STAFF RECOMMENDATION
1322 6th Avenue North
September 20, 2017

Application: Violation; Site Improvements / Appurtenances

District: Germantown Historic Preservation Zoning Overlay

Description of Project: The applicant conducted work differently than what was approved by the MHZC in 2016. Work includes: not removing a curb cut, improving the curb cut with concrete rather than continuing the brick sidewalk, adding a vehicular gate with brick posts rather than the fencing.

Figure 1: The approved plan shows that the sidewalk and the fence would be continuous across the area that originally had a curb cut.

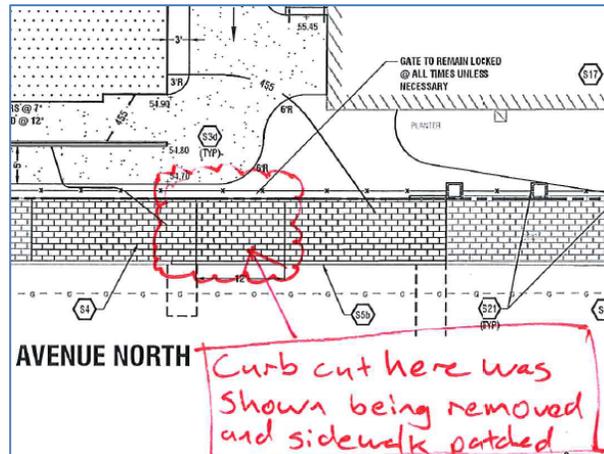
Prior to the 2016 approval there were two curb cuts from 6th Avenue North into the property. The 2016 infill plans showed one of those remaining and the other as being removed with the sidewalk patched with brick to match the adjacent sidewalk area. The proposed fencing was to be a continuous metal fence.

driveway to the right of the building at 1318 6th Avenue North. The driveway between 1318 and 1322 6th Avenue was not described because it was shown as being removed on the submitted site plan. That site plan was attached to the Staff Recommendation. A condition of approval was that material for the fencing be approved by staff. After conditional approval and receiving additional information, an updated site plan was attached to “Historical Commission Permit 201600181” which also showed the second curb cut as being removed, the sidewalk patched with brick and a continuous fence.

Figure 2: Current conditions show that the driveway and fencing proposed and permitted are now a curb cut and gate.

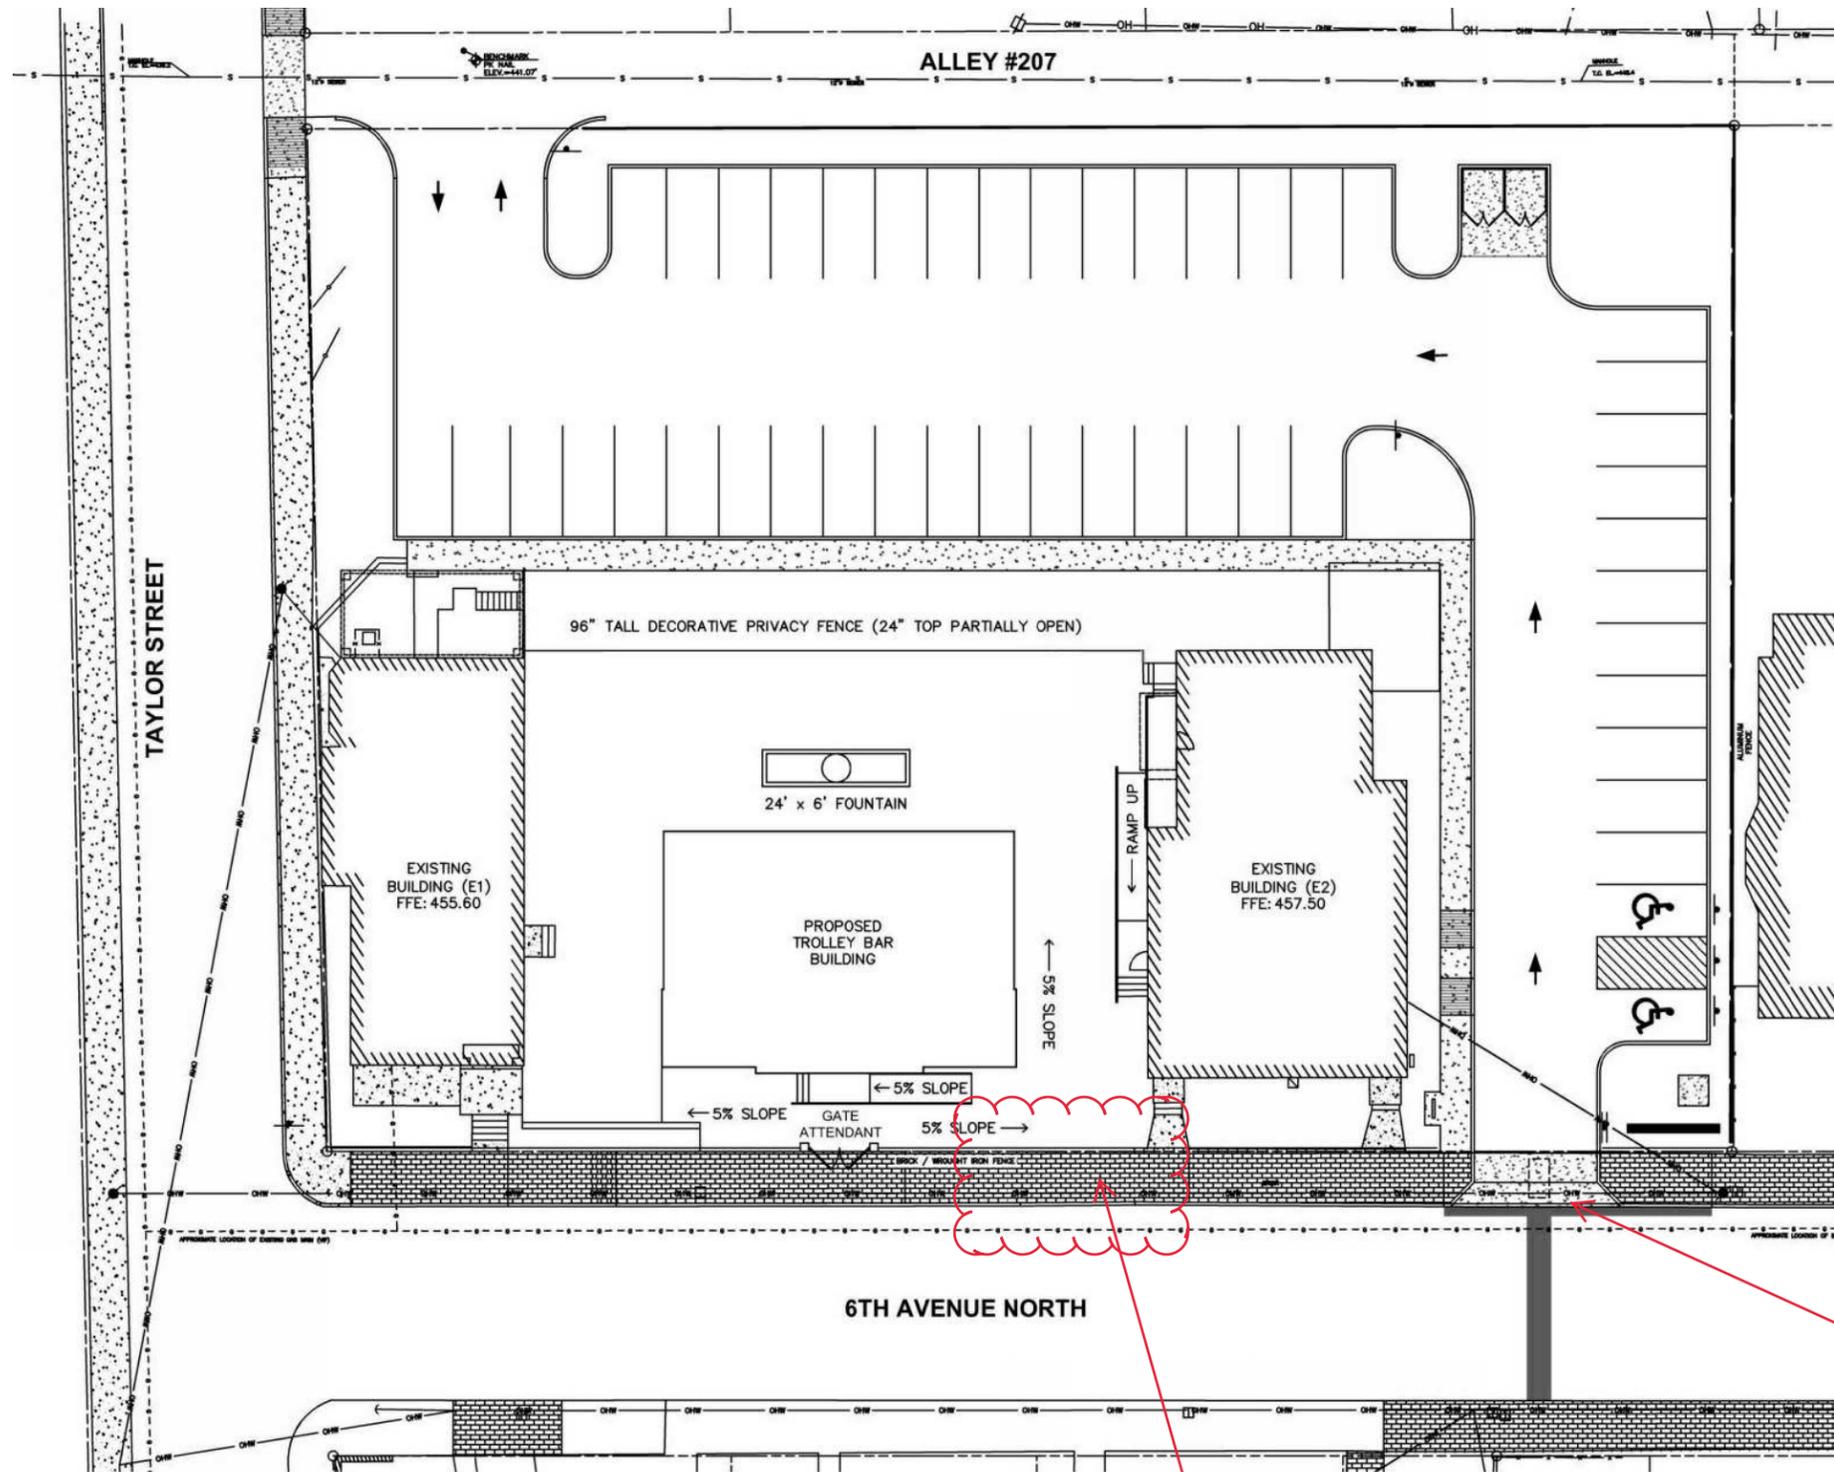
As the construction of the infill and outbuilding are nearing completion, rather than removing the second curb cut and continuing the brick sidewalk the applicant has repaved the curb cut with new concrete and added a vehicular gate with brick pillars.

The concrete for the sidewalk does not meet section 5.2.1 which requires that new sidewalks “remain visually compatible with the materials and placement of historic sidewalks. The brick sidewalks in this neighborhood, in either new or historic brick, are a character defining feature of the neighborhood. In addition, Section 5.3.1 states that where curb cuts are allowed they should not be “visually dominant.” By changing the approved fence in this area to brick pillars with a double-gate and by disrupting the brick sidewalk with concrete, the vehicular access is now visually dominant and so does not meet section 5.3.1.

Since three sections of the design guidelines call for vehicular access to be from the alley and/or for existing curb cuts to be removed where there is alley access and because another curb cut was approved just a few feet down, staff finds that the improved curb cut does not meet the design guidelines.

The new gate does not meet section 5.1 for fences since it is no longer the fencing approved by the Commission and allowed by the design guidelines but a vehicular gate in a location where vehicular access does not meet the design guidelines.

Recommendation Summary: Staff recommends disapproval of the application to retain the curb cut and driveway at 1322 6th Avenue North, finding the proposal does not meet sections 5.2 for sidewalks, 5.2 for walkways and 5.3 for paving/driveways/parking areas and parking lots of the design guideline. Staff further recommends that curb cut be removed, the brick sidewalk continue across the expanse that is now concrete, and the fence be installed as originally permitted within 60 days.

Site Plan from May 2016 Staff Recommendation

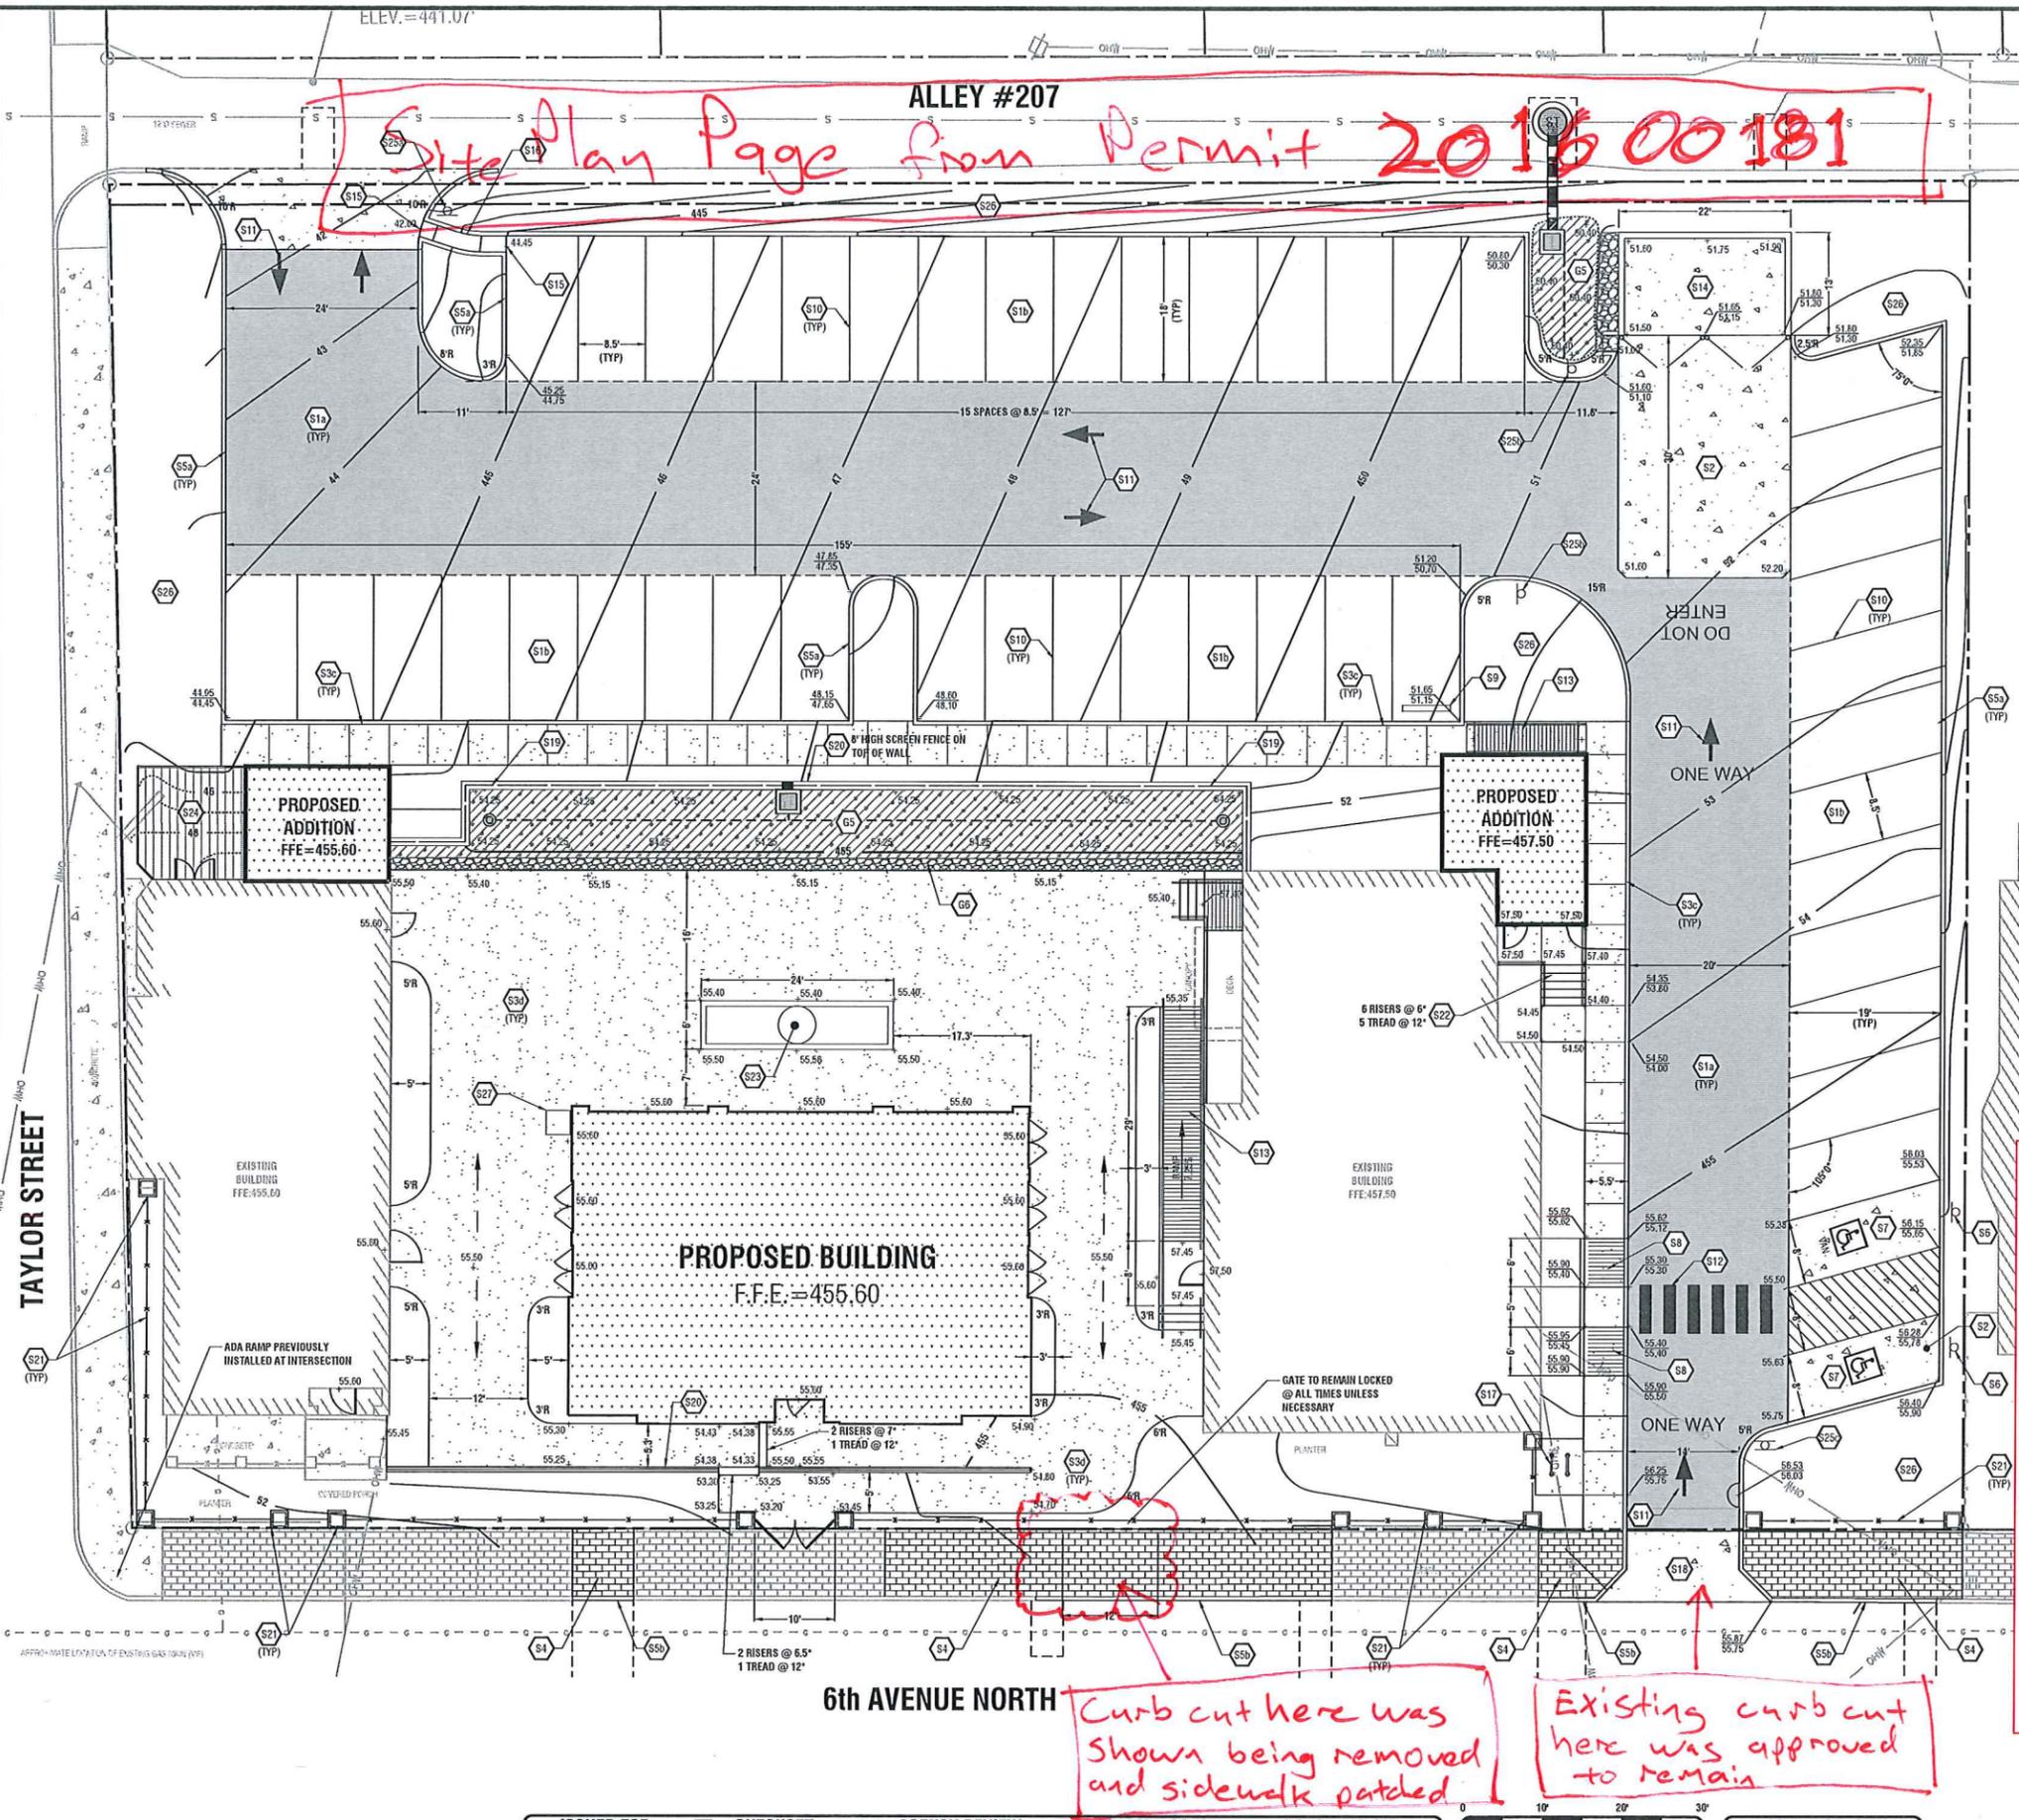
Existing curb cut here was to remain.

Existing curb cut here is shown being removed and the sidewalk patched with brick.
